VALUE ENGINEERING REPORT

New I-985 Interchange
Project Nos. NHS00-0000-00(425) CSNHS 0008-00(796)(797)
PI Nos. 0000425, 0008796, 0008797
Hall County

February 17, 2010

Idea No.: B-5
Client: GDOT
Sheet 2 of 4

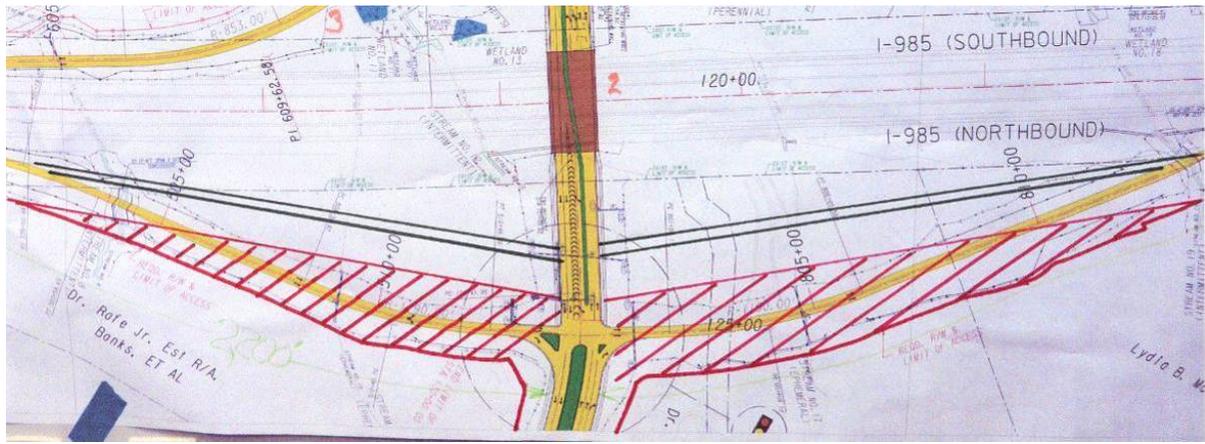
IDEA No.: B-5	Sheet No.: 1 of 4	CREATIVE IDEA: Shift the NB off-ramp and NB on-ramp in approximately 200 feet to save R/W.
-------------------------	-----------------------------	--

The current design has the NB off-ramp and NB on-ramp intersection with Martin Road approximately 400 feet east of the centerline of I-985.

This recommendation would shift / realign the NB off-ramp and NB on-ramp intersection with the Martin Road Extension approximately 200 feet closer to I-985.

Shifting the NB off-ramp and NB on-ramp 200 feet closer to I-985 will still maintain about 700 feet between ramp interchanges (provides more than the 660 feet required for intersections). Shifting these ramps in toward I-985 will save R/W, reduce the project's impact to the community, and reduce project cost.

Idea No.: C-1
Client: GDOT
Sheet 2 of 5

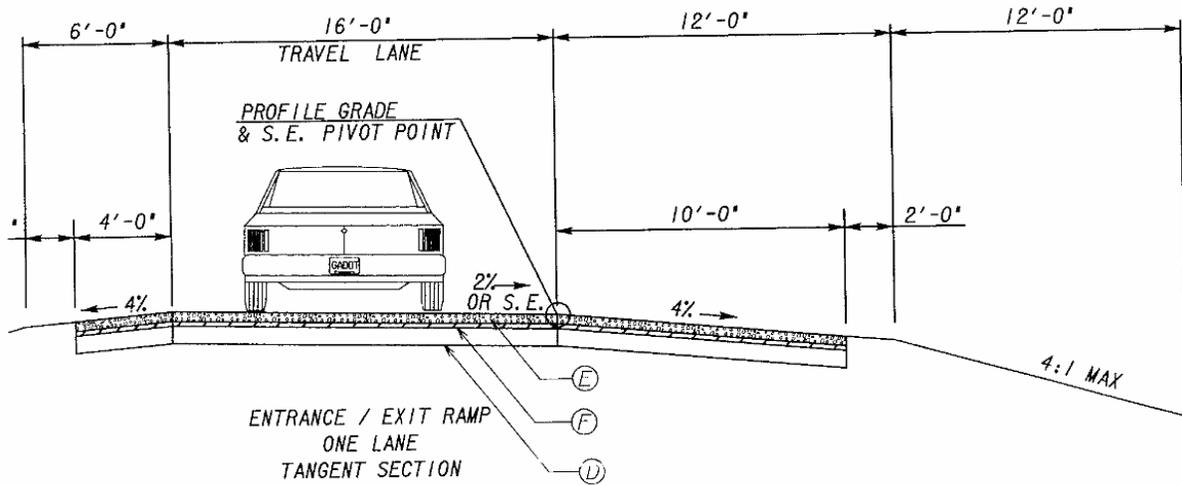
IDEA No.: C-1	Sheet No.: 1 of 5	CREATIVE IDEA: Use full depth asphalt pavement in-lieu-of PC concrete pavement to construct the Interchange ramps
-------------------------	-----------------------------	---

The current design includes PC concrete pavement for the Interchange ramps. The pavement section consists of 8 inches of plain PC pavement, 3 inches of asphalt, and 12 inches of GAB. The two-lane ramps include the same PC Pavement section for the 10-foot outside and 4-foot inside shoulders.

This recommendation would use full-depth asphalt pavement in lieu of PC concrete pavement for the Interchange ramps.

The current GDOT practice is to use PC concrete pavement for all Interstate ramps. PC concrete pavement does not rut in the approach areas to the cross road intersection. However, full depth asphalt pavement can provide a significant cost savings over PC concrete pavement even with scheduled maintenance (milling and resurfacing every 10 years).

Idea No.: C-2
Client: GDOT
Sheet 2 of 4

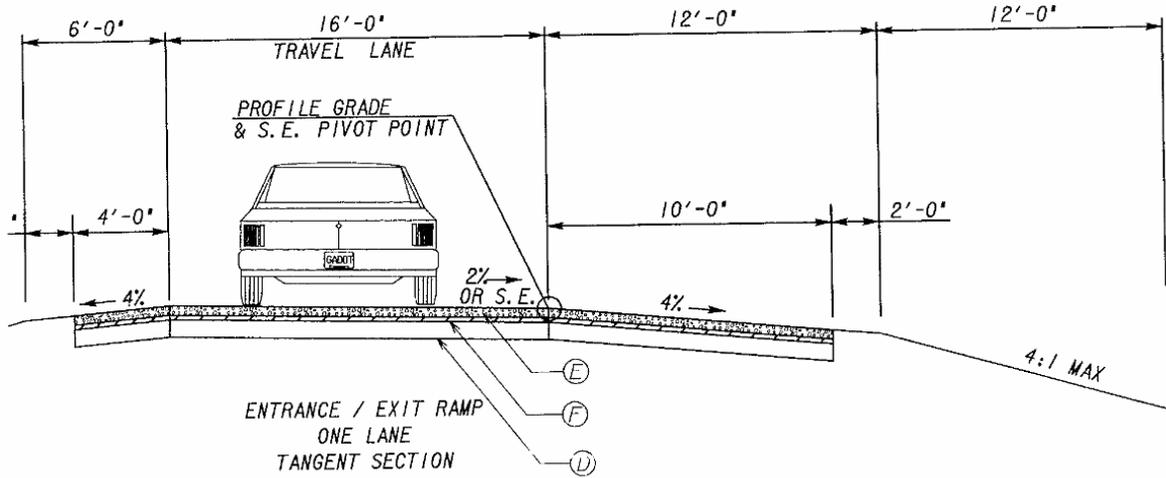
IDEA No.: C-2	Sheet No.: 1 of 4	CREATIVE IDEA: Use asphalt pavement for the ramp shoulders in-lieu-of PC concrete shoulders.
-------------------------	-----------------------------	--

The current GDOT practice is to use PC concrete pavement for all Interstate ramps. However, using full depth asphalt pavement for the ramp shoulders can provide a significant cost savings over PC concrete pavement.

Idea No.: F-1
Client: GDOT
Sheet 2 of 4

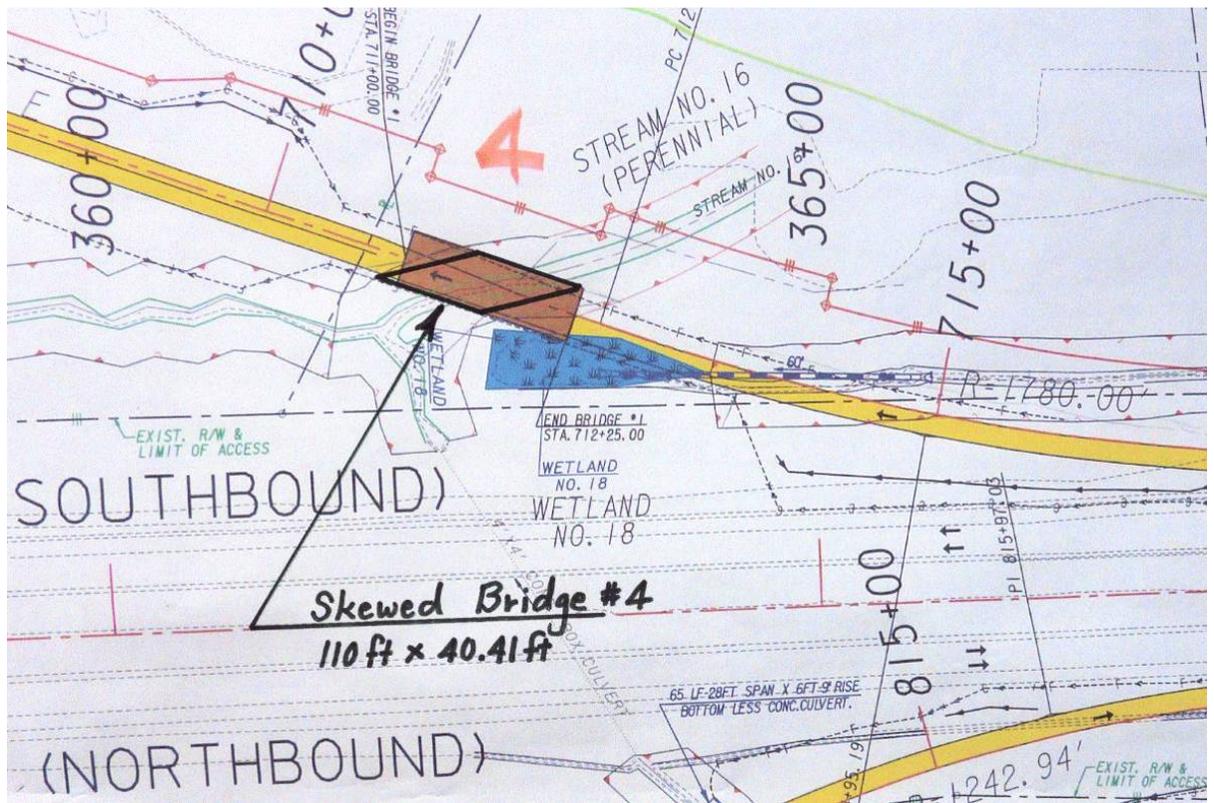
IDEA No.: F-1	Sheet No.: 1 of 4	CREATIVE IDEA: Construct Bridge #4 on skew instead of rectangular to reduce the deck area and use smaller beams.
-------------------------	-----------------------------	--

This recommendation would skew the bridge bents parallel to the stream and use AASHTO Type I modified PSC beams.

Idea No.: F-1.1
Client: GDOT
Sheet 2 of 4

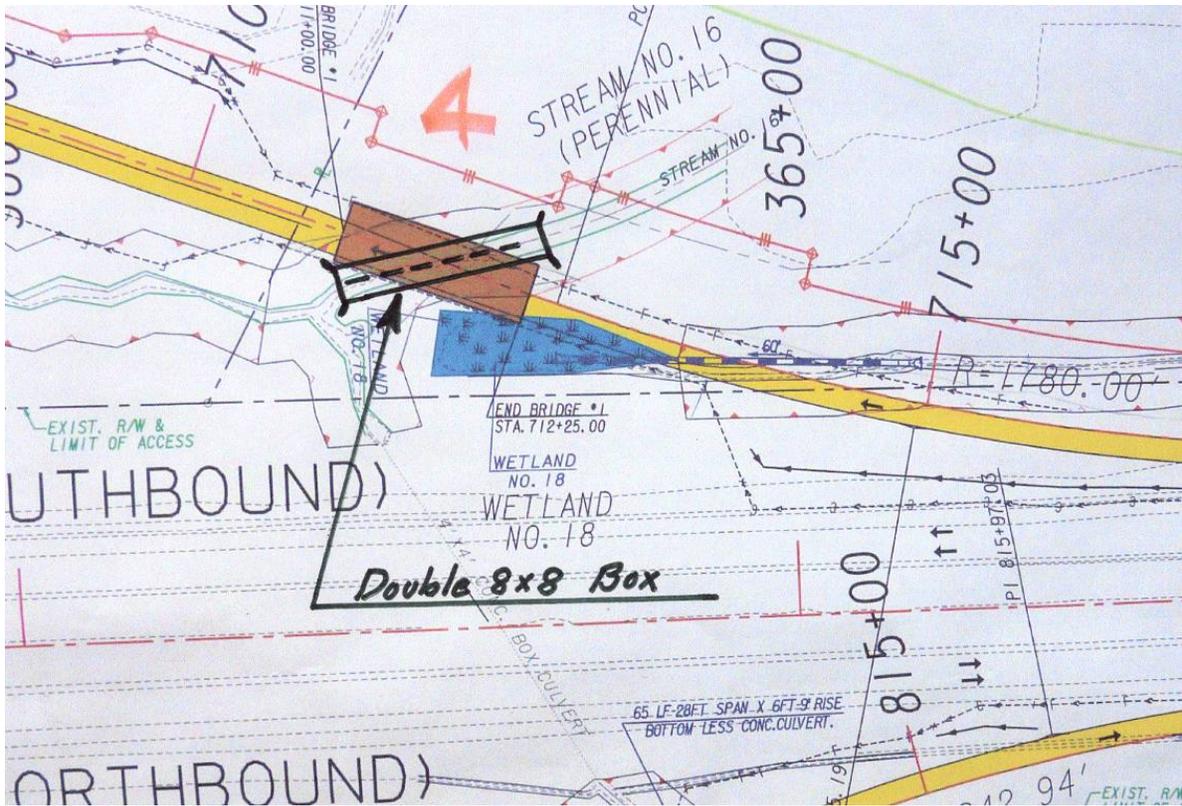
IDEA No.: F-1.1	Sheet No.: 1 of 4	CREATIVE IDEA: <u>Alternative to F-1</u> Replace Bridge #4 with a Double 8-foot x 8-foot concrete box culvert.
---------------------------	-----------------------------	--

This recommendation would replace Bridge #4 with a Double 8-foot x 8-foot concrete box culvert 120 feet long.

Idea No.: M-1
Client: GDOT
Sheet 2 of 4

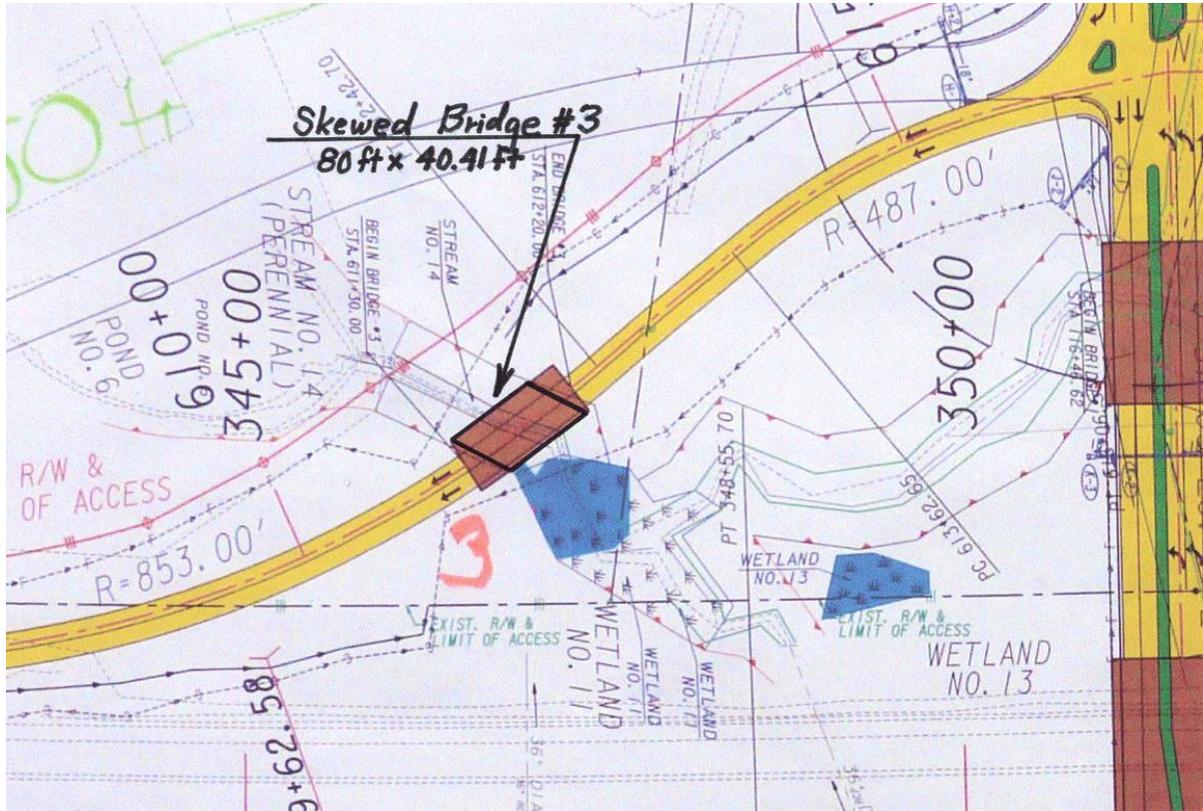
This recommendation would skew the bridge bents parallel to the stream and use AASHTO Type I modified PSC beams.

Idea No.: M-1.1
Client: GDOT
Sheet 2 of 4

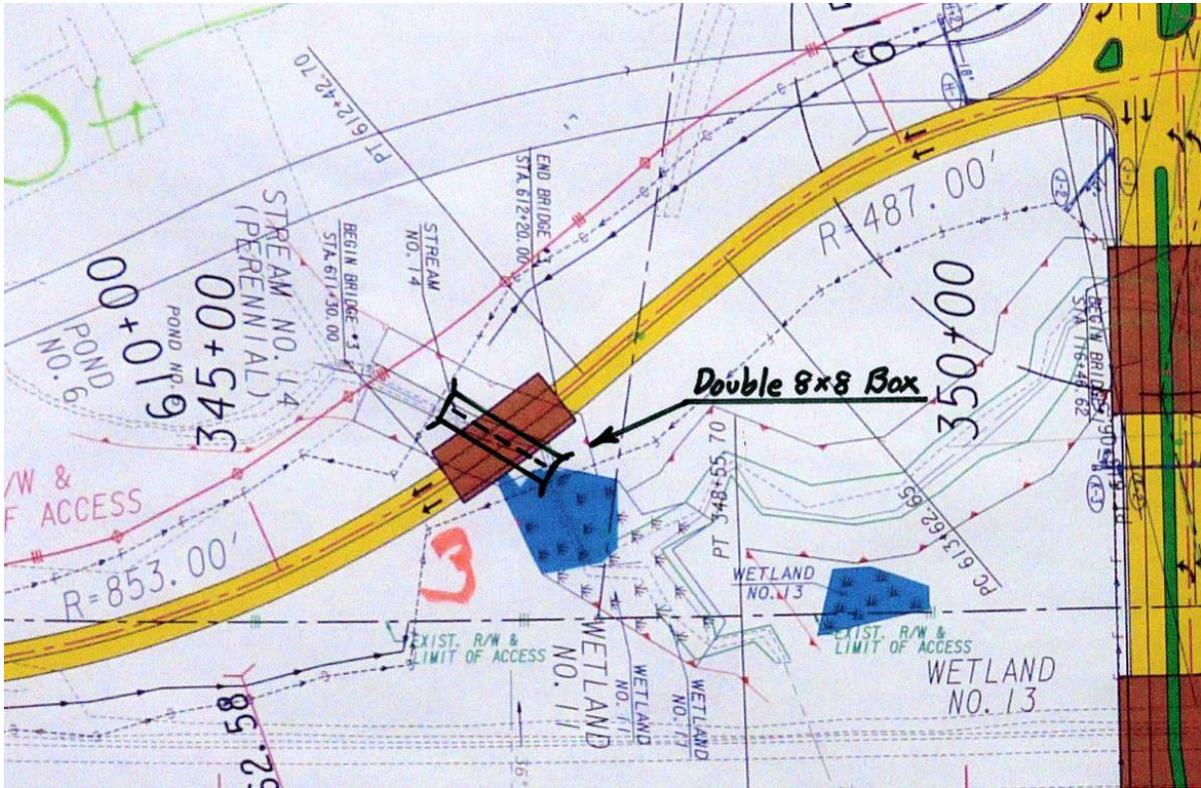
IDEA No.: M-1.1	Sheet No.: 1 of 4	CREATIVE IDEA: Replace Bridge #3 with a Double 8-foot x 8-foot concrete box culvert.
---------------------------	-----------------------------	--

This recommendation would replace Bridge #3 with a Double 8-foot x 8-foot concrete box culvert 90 feet long.

Idea No.: R-1
Client: GDOT
Sheet 2 of 4

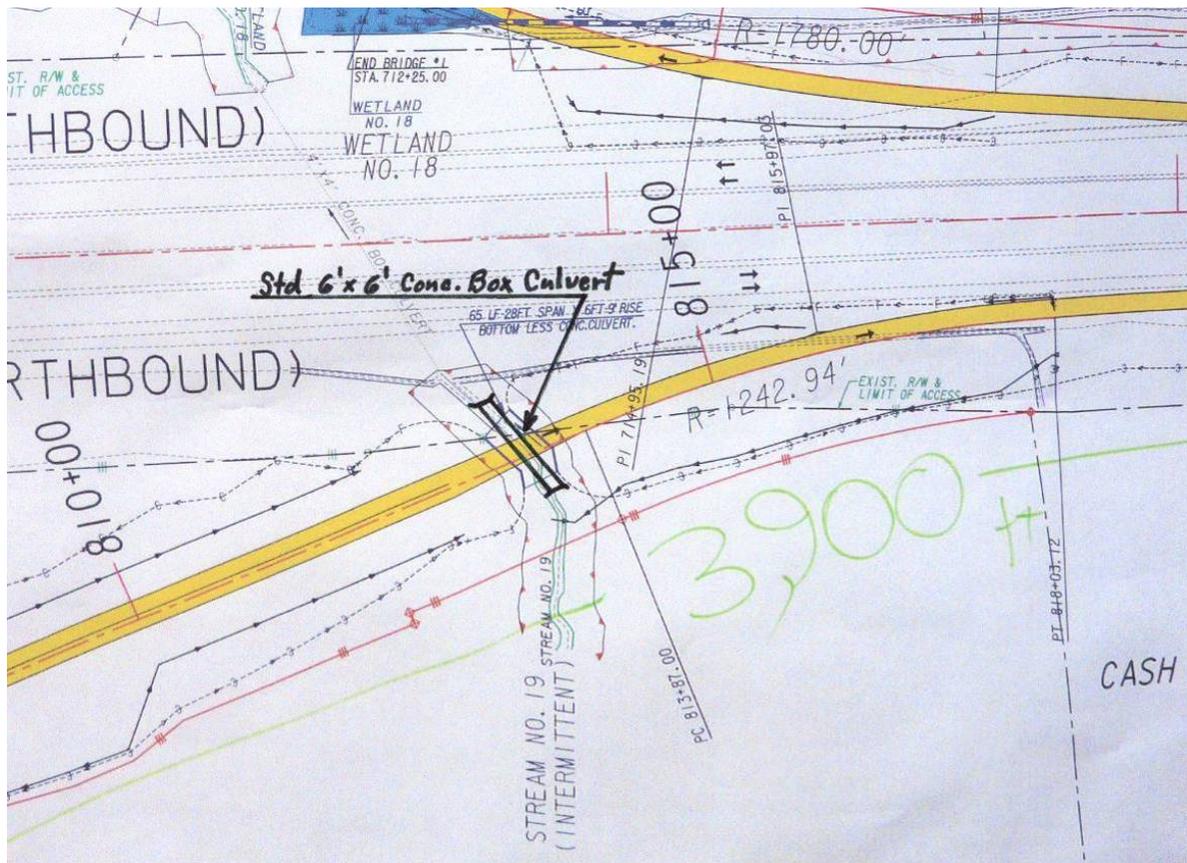
IDEA No.: R-1	Sheet No.: 1 of 4	CREATIVE IDEA: Replace the bottomless culvert over Stream #19 on the NB on-ramp with a standard 6-foot x 6-foot concrete box culvert.
-------------------------	-----------------------------	--

This recommendation would replace the large bottomless culvert with Georgia Standard 6-foot x 6-foot concrete box culvert.

Idea No.: X-1
Client: GDOT
Sheet 2 of 4

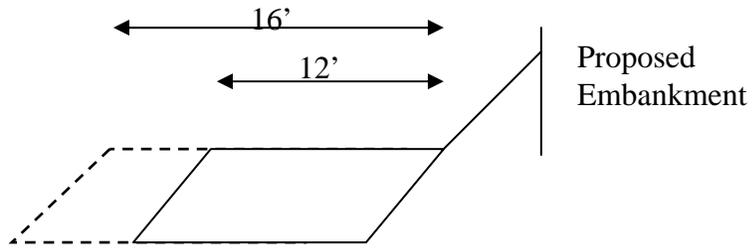
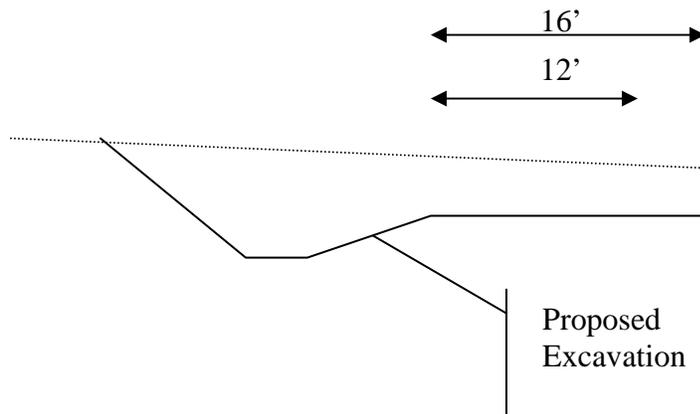
IDEA No.: X-1	Sheet No.: 1 of 4	CREATIVE IDEA: Reduce the shoulder width to 12 feet on the Martin Road Extension.
-------------------------	-----------------------------	---

The revised shoulder width provides adequate width for the curb & gutter and sidewalk. It would be more consistent with the shoulders widths (10 feet and 12 feet) on Thurmon Tanner Parkway and SR 13. It will reduce earthwork, project R/W, and lower the cost of the project.

Idea No.: X-5
Client: GDOT
Sheet 2 of 4

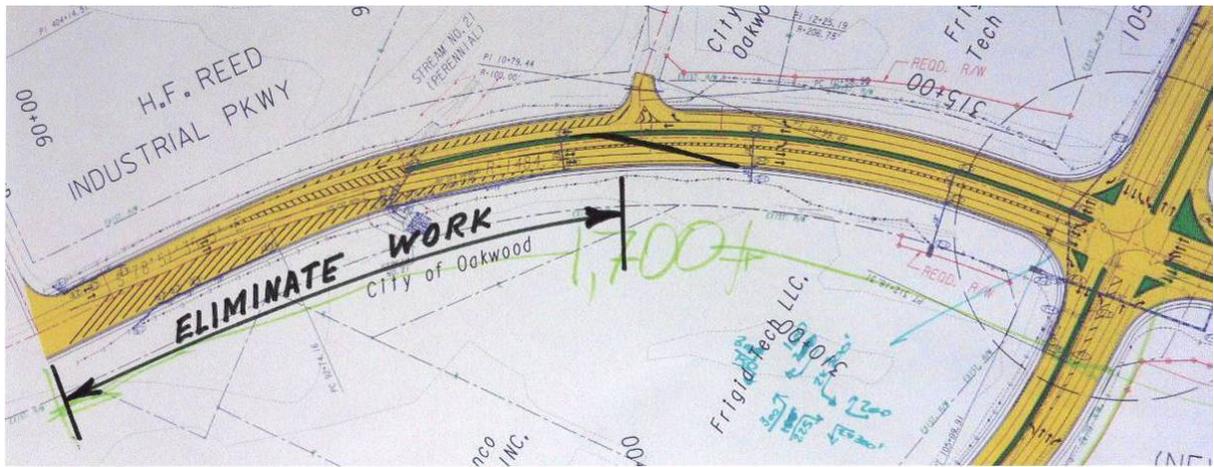
IDEA No.: X-5	Sheet No.: 1 of 4	CREATIVE IDEA: End the reconstruction of the H.F. Reed Industrial Parkway at Station 99.
-------------------------	-----------------------------	--

Original Concept: Construct the full width widening as shown on the concept plan.

Idea No.: X-6
Client: GDOT
Sheet of 4

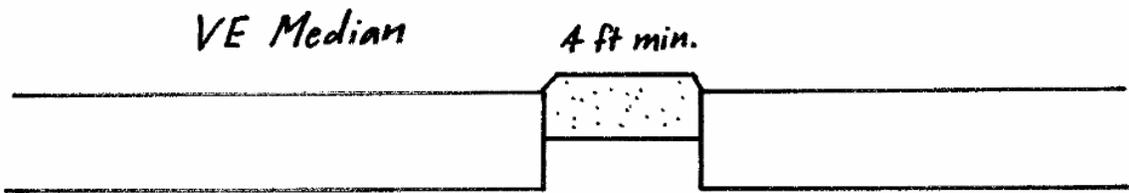
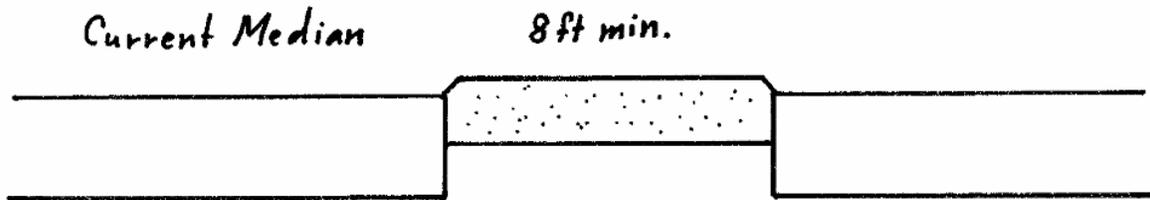
IDEA No.: X-6	Sheet No.: 1 of 4	CREATIVE IDEA: Reduce the median width four feet on the Martin Road Extension.
-------------------------	-----------------------------	--

Idea No.: X-7
Client: GDOT
Sheet 2 of 4

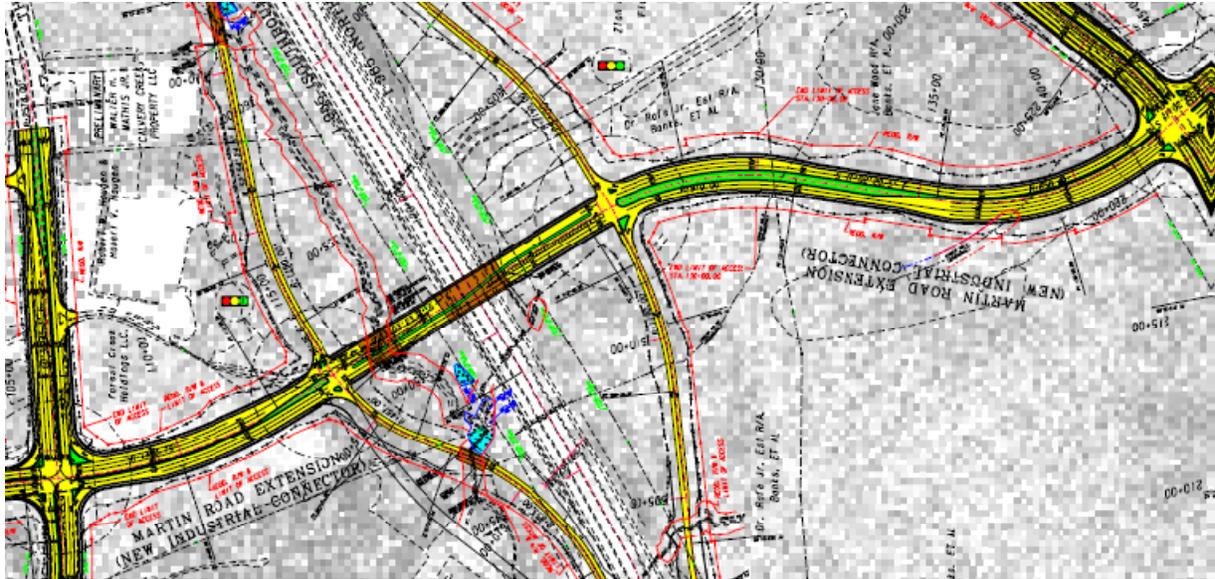
IDEA No.: X-7	Sheet No.: 1 of 4	CREATIVE IDEA: Construct 11-foot lanes in-lieu-of 12-foot lanes along the Martin Road Extension between Thurmon Pkwy and SR 13
-------------------------	-----------------------------	--

Idea No.: X-10
 Client: GDOT
 Sheet 2 of 5

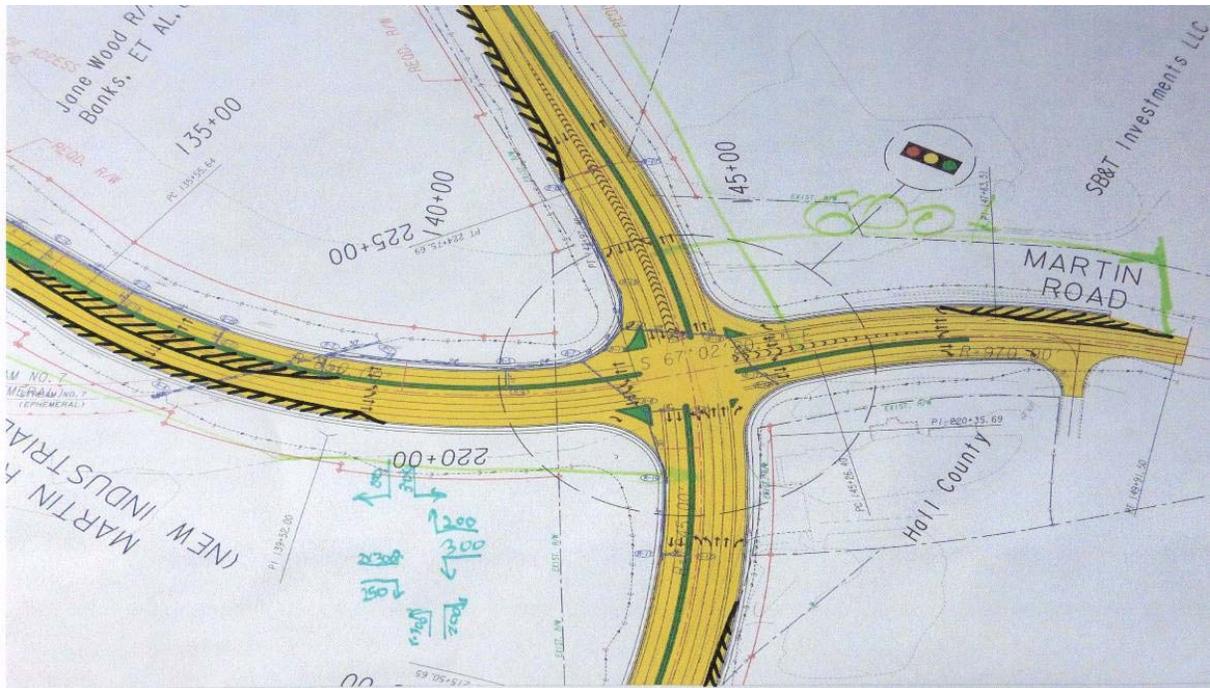
IDEA No.: X-10	Sheet No.: 1 of 5	CREATIVE IDEA: Reduce the length of the turn lane storage areas to the lengths shown in the traffic study report.
--------------------------	-----------------------------	---

The turn bay storage lengths in the table were developed based on the 95 percentile queue for the worst case scenario (AM or PM Peak Hour Design Year). These lengths do not include deceleration or taper lengths.
